**Economic Commission for Europe****Inland Transport Committee****World Forum for Harmonization of Vehicle Regulations****Working Party on General Safety Provisions****Ninety-ninth session**

Item 7 of the provisional agenda

**Regulation No. 46 (Devices for indirect vision)****Proposal for amendments to Regulation No. 46****Submitted by the expert from the United Kingdom of Great Britain and Northern Ireland\***

Figures 8c and 8d:

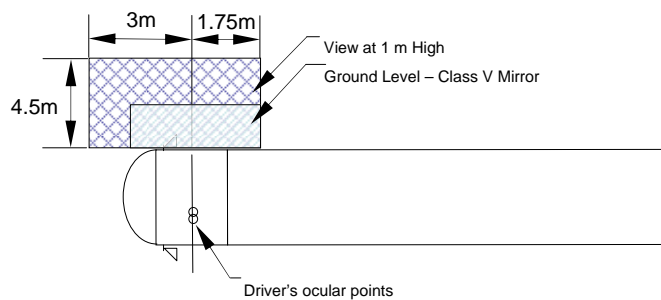
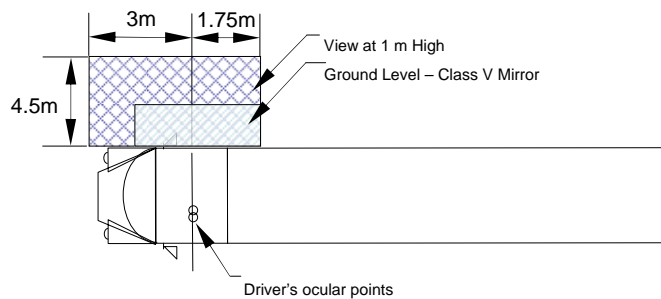
- “15.2.4.5.6. on the passenger side only, the field of vision shall also be such that the driver can see [part of] an object 1m high and 30cm in diameter which is outside the field defined in 15.2.4.5.1. to 15.2.4.5.4. but within the field bounded by the following vertical planes (see Figures 8c and 8d):

- 15.2.4.5.7. in the transverse direction, the parallel plane passing at a distance of 4.5 m in front of the plane mentioned in paragraph 15.2.4.5.1.
- 15.2.4.5.8. to the rear, the plane parallel to the vertical plane passing through the driver's ocular points and situated at a distance of 1.75 m behind that plane.

- 15.2.4.5.9. to the front, the plane parallel to the vertical plane passing through the driver's ocular points and situated at a distance of 3 m in front of that plane. This field of vision may be partially provided by a front mirror (see figure 8e).
